Service Alert

BODY CONTROL MODULE (BCM) CONFIGURATION

Service Alert No.: SA-032/19

2019 Mazda3

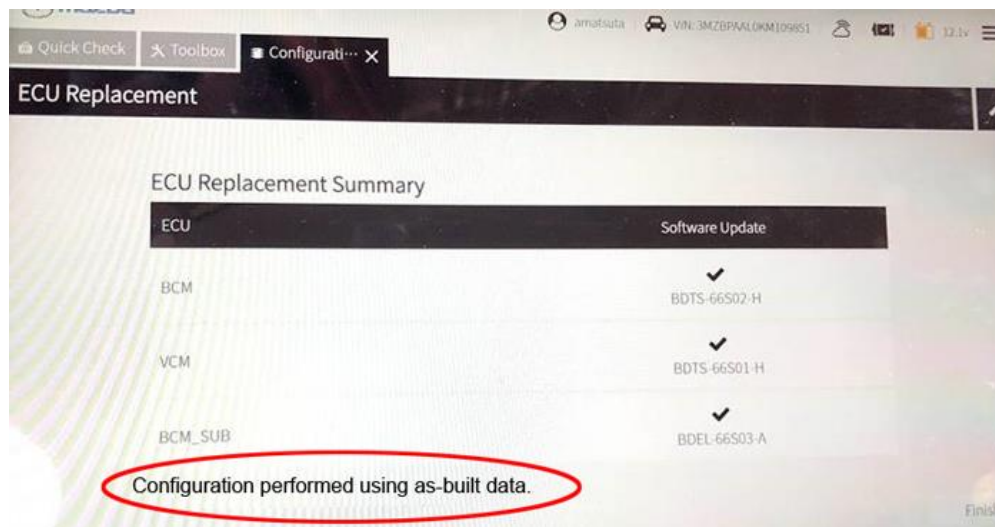
2. Open the front doors on both sides and the trunk (4SDN) / Lift gate (5HB) and keep them open until the BCM removal/installation procedure is completed.

NOTE: The ESU and Door-ESU synchronization needs to be performed when the BCM is replaced. It is

performed automatically at the timing of first ignition ON, and to complete the synchronization process successfully, the front doors and trunk lid/lift gate need to be opened.
